ADDENDUM NO. 1

December 15, 2025

**COMSTOCK HALL 5TH FLOOR
LAB AND SUPPORT SPACE
RENOVATIONS**
129 Garden Ave
Ithaca, NY 14853
SWBR Project Number 25044.00

Cornell University
Ithaca, NY 14853

M-402R

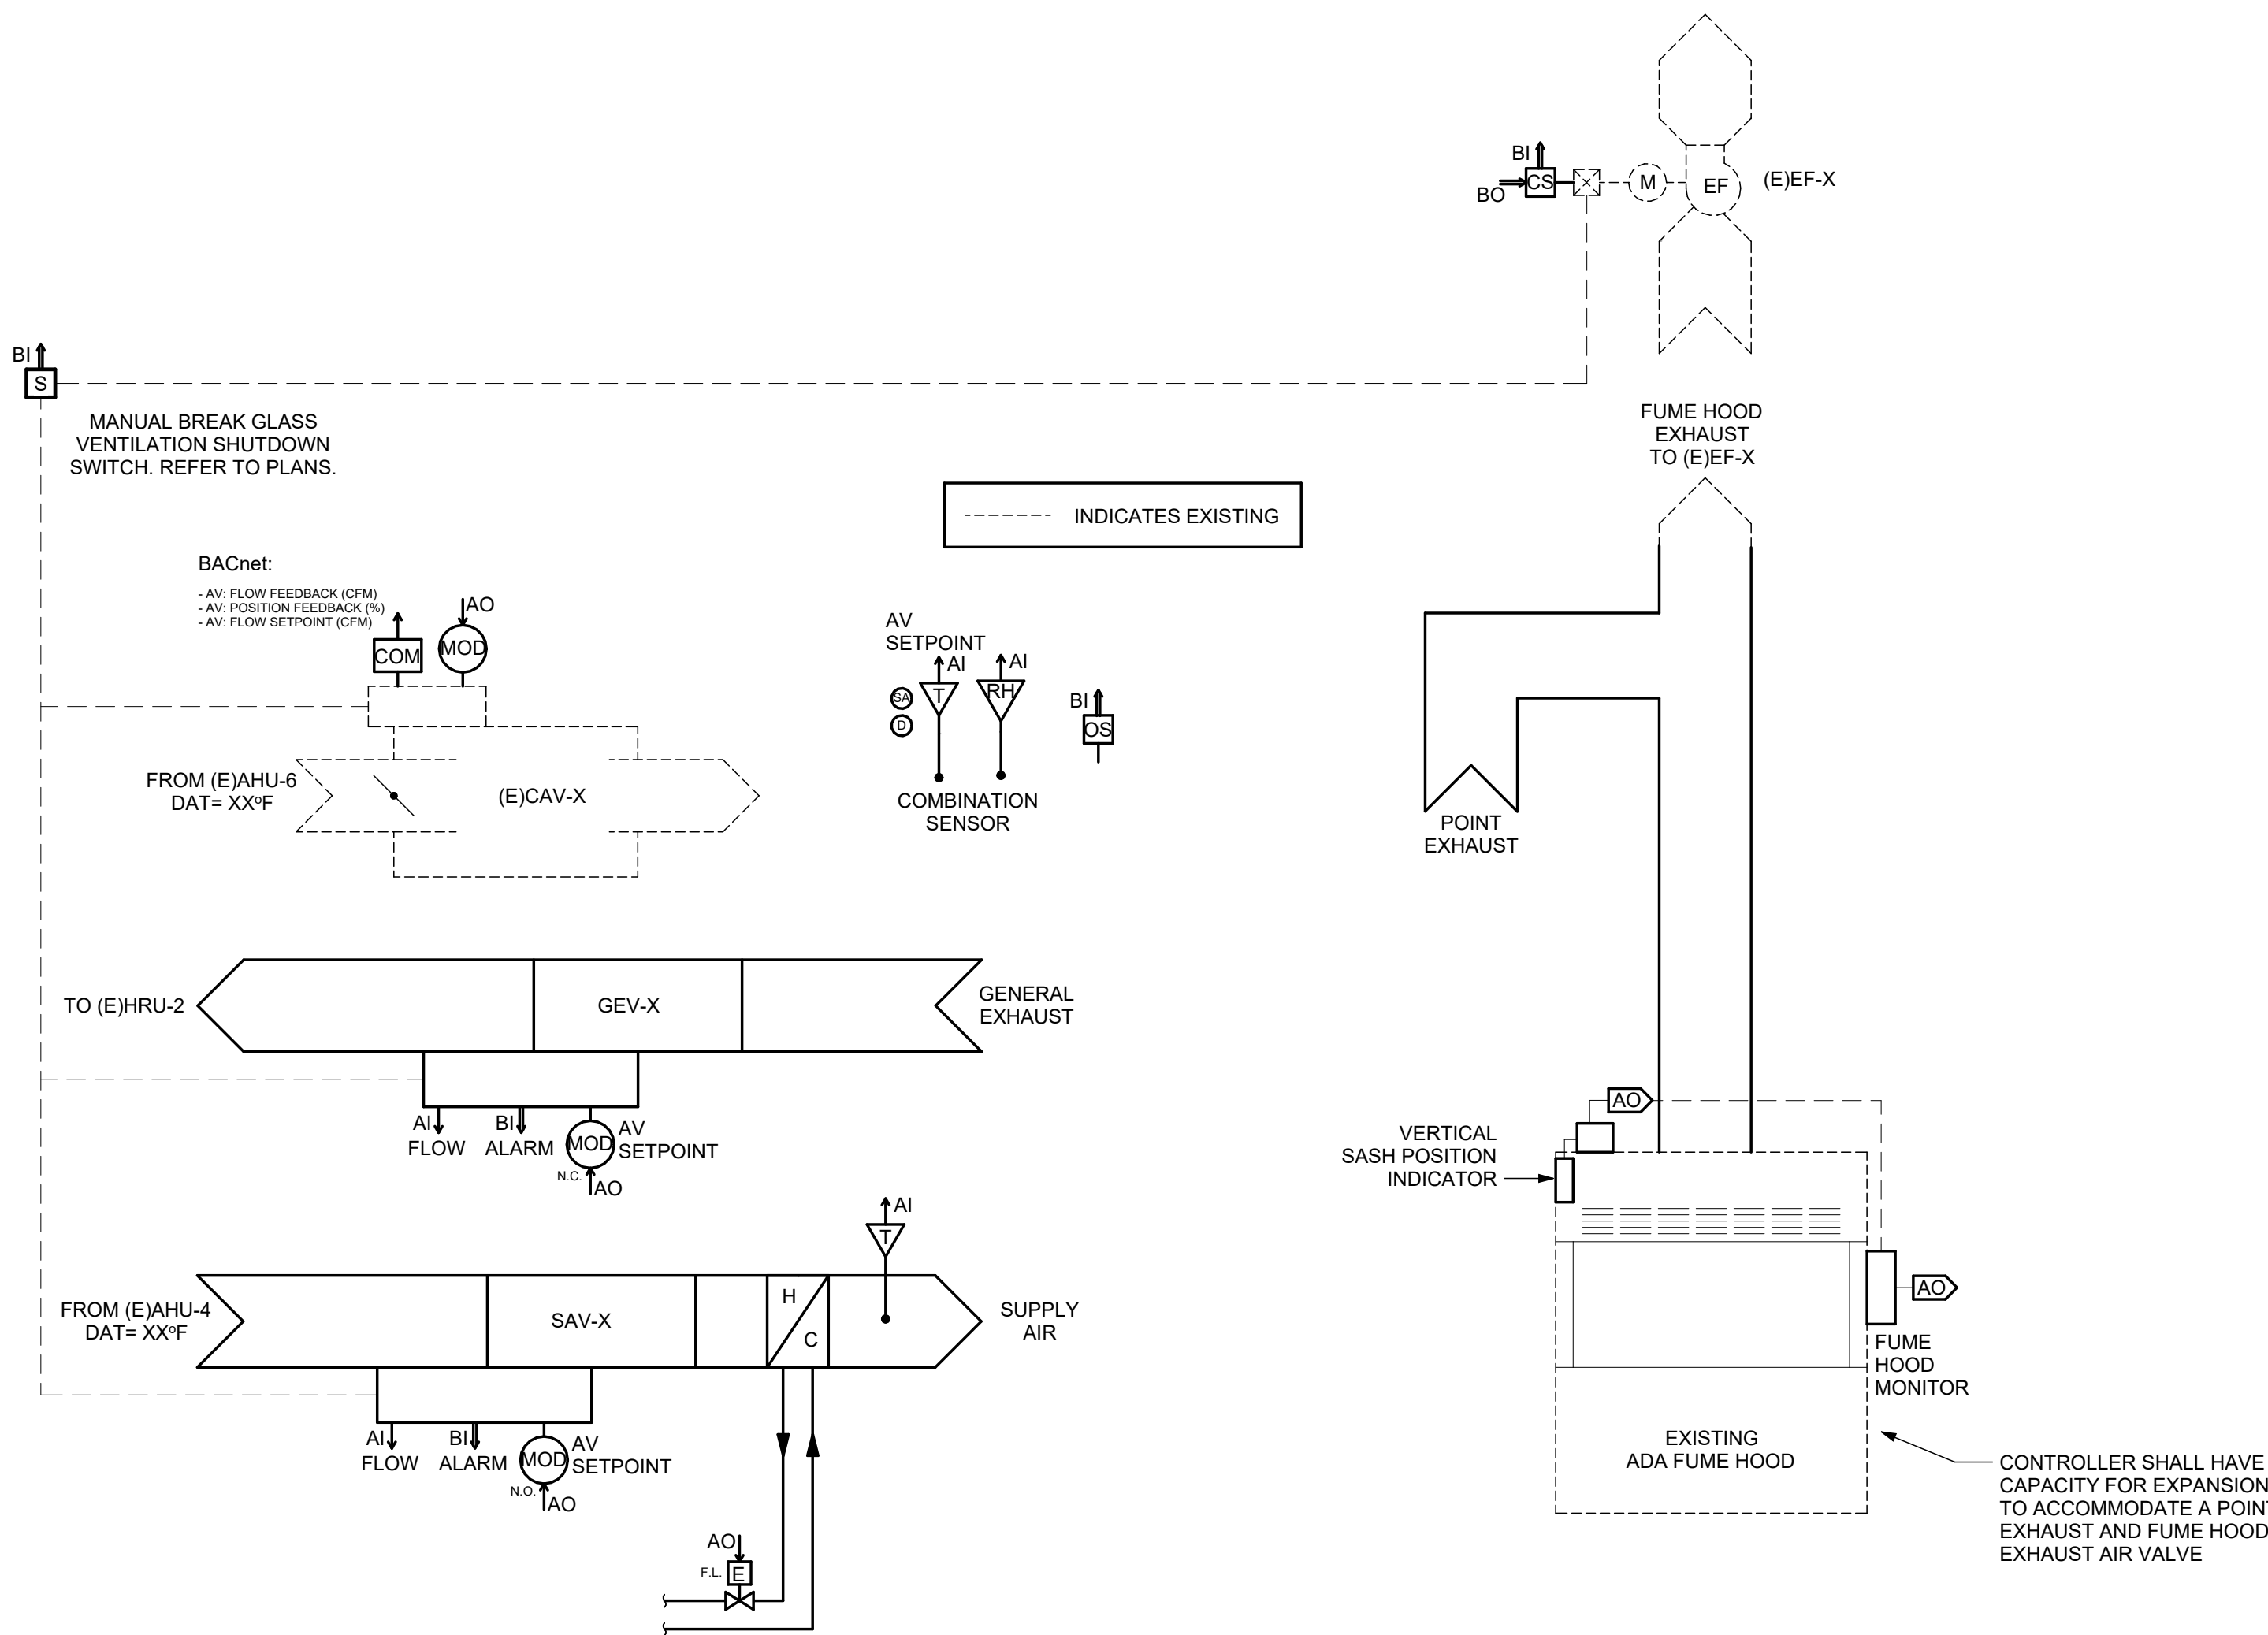
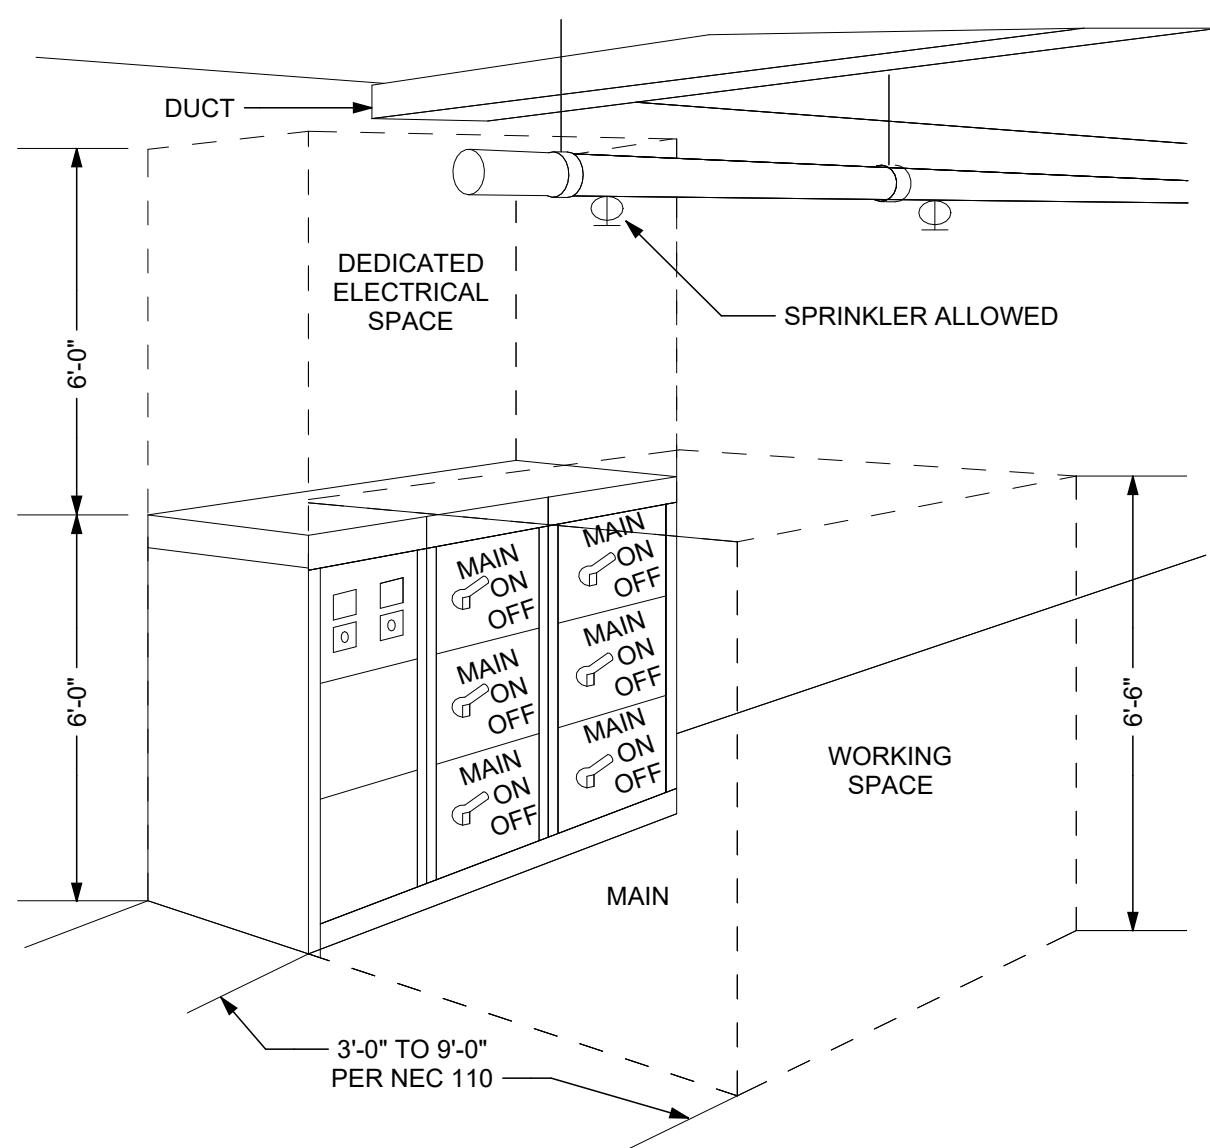
Item 12. Drawing M-402 – Control Schematic and System Summaries

DELETE in its entirety.

REPLACE with revised Drawing M-402R attached.
